# UNITED STATES PATENT AND TRADEMARK OFFICE

10/612,848

**Office Action Summary**

## **DETAILED ACTION**

Figure 1 of Furuya et al

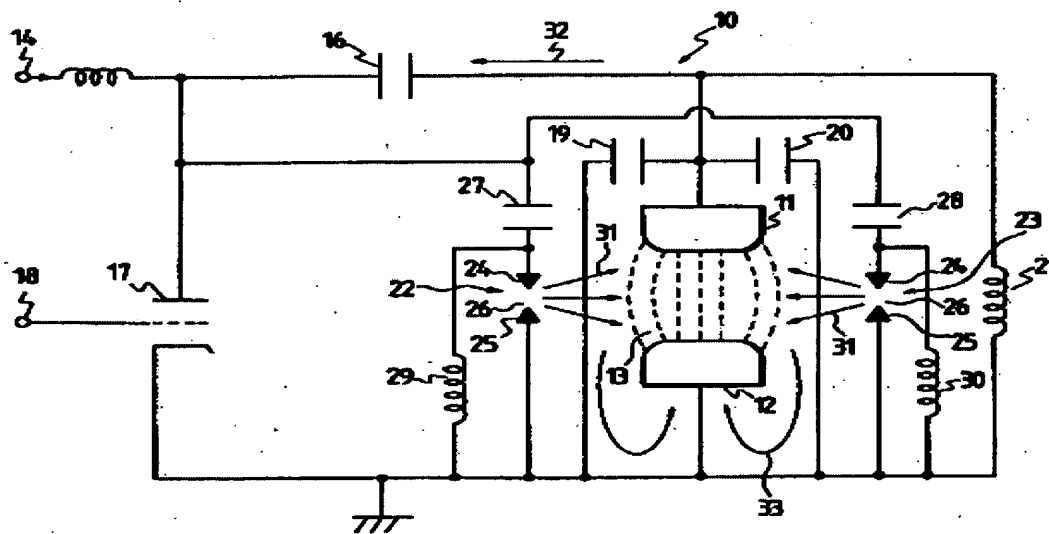
Furuya et al illustrates in figure 1 a gas laser (10) having an electric circuit [applicant's pulser] formed by the terminal (14), switch (17), capacitors (16,19,20,27,28) and charging coils (21,29,30), column 3 lines 10-56. The gas laser also having a pair of discharge electrodes (11) and (12) [applicant's pair of electrodes], a gas medium within a pressure container (not shown) column 2 lines 62-68 and preionizers (22) and (23) [applicant's suitable means] for preionizing the laser gas, column 3 lines 57-61. Figure 1 illustrates a charging coil (21) [applicant's means to isolate] between capacitor (16) [applicant's sustainer pulse] and capacitors (19) and (20) [applicant's spiker]. Column 5 lines 12-28, discloses a delay [applicant's means to delay] in time between the

preionization discharge [applicant's pre-ionising pulse] and the main discharge [applicant's spiker], which is provided by the preionization capacitors (22,28) having a smaller capacitance than the capacitors (19,20) of the main discharge capacitors, as illustrated in figure 2 (capacitors and inductors are equivalent both store energy). In column 7 lines 7-12, Furuya et al discloses applying the circuit of the invention to a TEA (Transverse excitation-atmospheric pressure) carbon dioxide (CO<sub>2</sub>) laser.

In figure 1 Furuya et al illustrates profiled electrodes (11) and (12) with rounded edges.

In figure 1 Furuya et al illustrates a switch (17) [applicant's single switch] and terminal (14) receiving high-voltage electric energy from a power supply, column 3 lines 10-17.
